NOTE ON IRRIGATION
IN THE
JHALAWAR STATE,

BY
THE CONSULTING ENGINEER FOR IRRIGATION IN
RAJPUTANA.

1903.

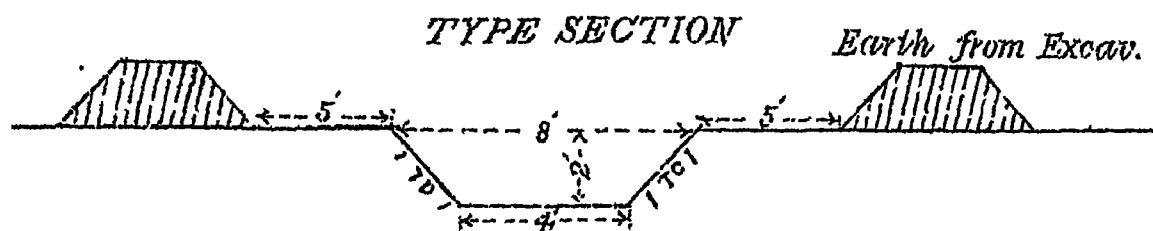
On the right bank 111 chains out of the 130 chains estimated for and set out have been partly excavated; and on the left bank 17 chains in extension of the 30 chains originally executed when the tank was constructed. In excavating the channels vertical sides have been given to save expense, and the earth excavated has been thrown up anyhow on either edge, even on sloping ground. This is a mistake, as in black soil the vertical sides will give way, and the earth on the edges is liable to fall in at any time. Except in rock and hard morrum, a slope of 1 to 1 should be given to the sides when constructing the channels, templates being constructed of the section of channel as a guide to the mates in charge.

On level ground, a berm of *at least* 5 ft. on either side should be given, and the earth excavated formed into a bank of proper section.

It will be found more economical to do this at once, will save any chance of sides and earth excavated falling back into the channel, and the channel can also be widened later if found necessary.

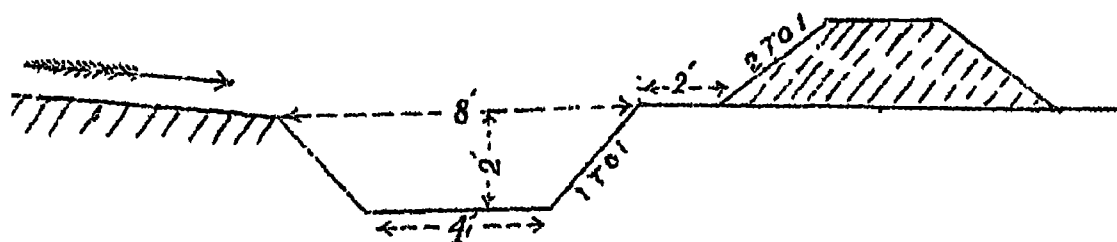
On side-long ground the earth excavated should be formed into a bank on the *lower side only*; and any surface drainage in the rains will then pass away down the channel.

The earth which has now been thrown up above the channel should be removed, otherwise in the rains it will all be washed back into the channel again, and cause trouble.

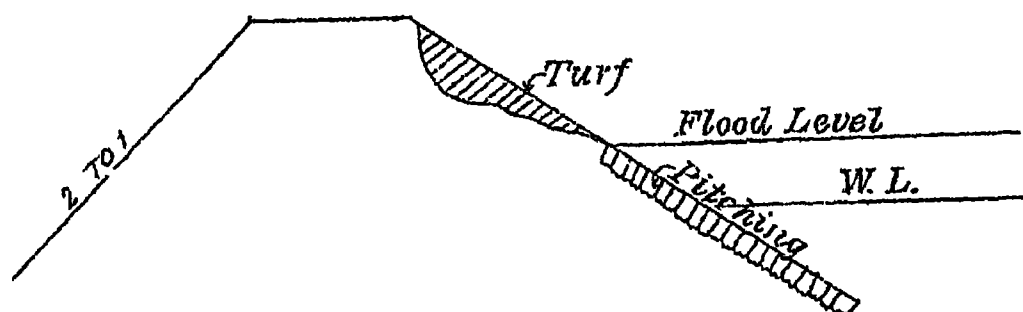
The apron below weir recommended by Consulting Engineer has been made, but later on, when there are funds, I would recommend the weir being placed at the south-east end by the Kishonpura Village, where there is rocky high ground, and the water would spill over this without doing harm, into the nullah below.

The dam would be extended on the north-west beyond the present weir till high ground is reached. At present the flood water damages the fields below at this end, and if the weir was altered I understand 25 bighas extra could be irrigated.

The front slope of dam, especially at south east end, wants making up, as it is cut up by waves, etc.; and it should be turfed down to flood level and pitched below, to prevent a recurrence of this.

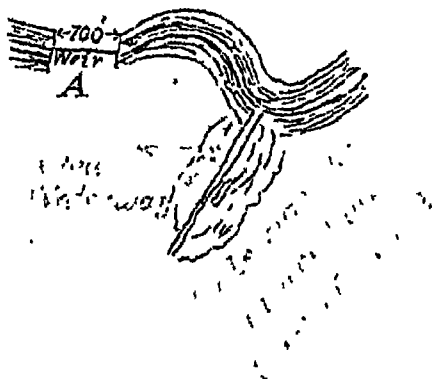
With regard to para. (8) the flood water has cut away the surface earth at the south weir down to rock, lowering the weir level to nearly 5 ft.

The water is cutting away the toe of the rear slope of the dam and a large area of good culturable land, in finding its way down to the nullah.

The Assistant Engineer proposes continuing the dam at this end on to high ground, and closing this weir altogether.

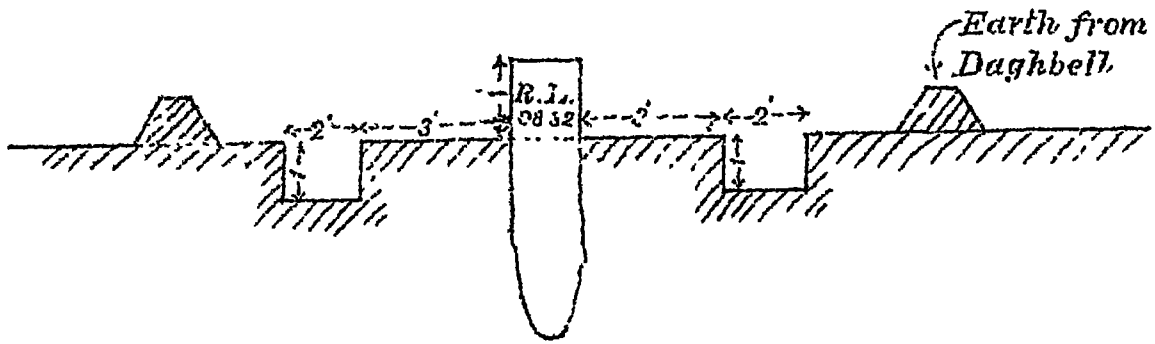
The dam is proposed to be 6 ft. wide at top, with front slope $2\frac{1}{2}$ to 1 and rear slope 2 to 1. Crest 5 ft. above weir level. The front slope should be made 3 to 1. The size of Sluice and Irrigation Channel required is not given, these should be worked out always by—

- (a) Finding the discharge per second required to empty the tank in four months (Rabi Irrigation season);
- (b) And as water is required simultaneously at first for Irrigation, the discharge required per second to give a first watering of 6 inches in 30 days of 12 hour flow to the whole area for which there is sufficient water.

This has been explained in detail to the Assistant Engineer.

SECTION

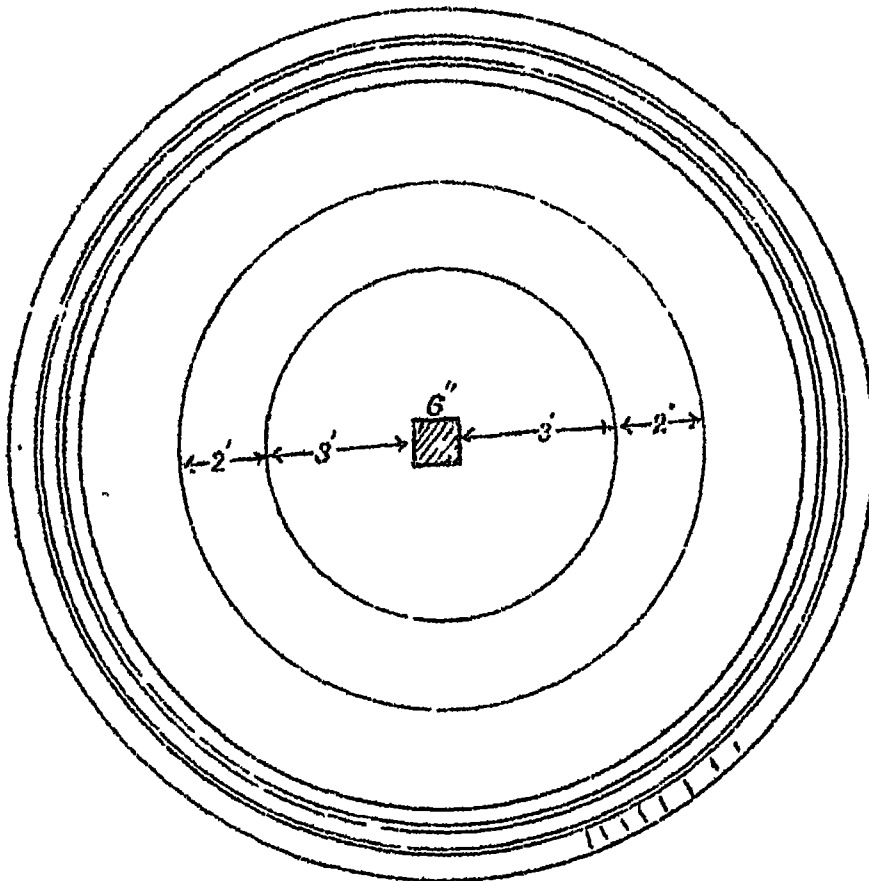
The line of the proposed dam was not daghbelled out, nor were there any permanent bench marks. Wherever

These bench marks should be stones set on edge, imbedded $1\frac{1}{2}$ in the ground, with a circular daghbell all round as per sketch, the number and reduced level, corresponding with Field Book, being marked on the stone.
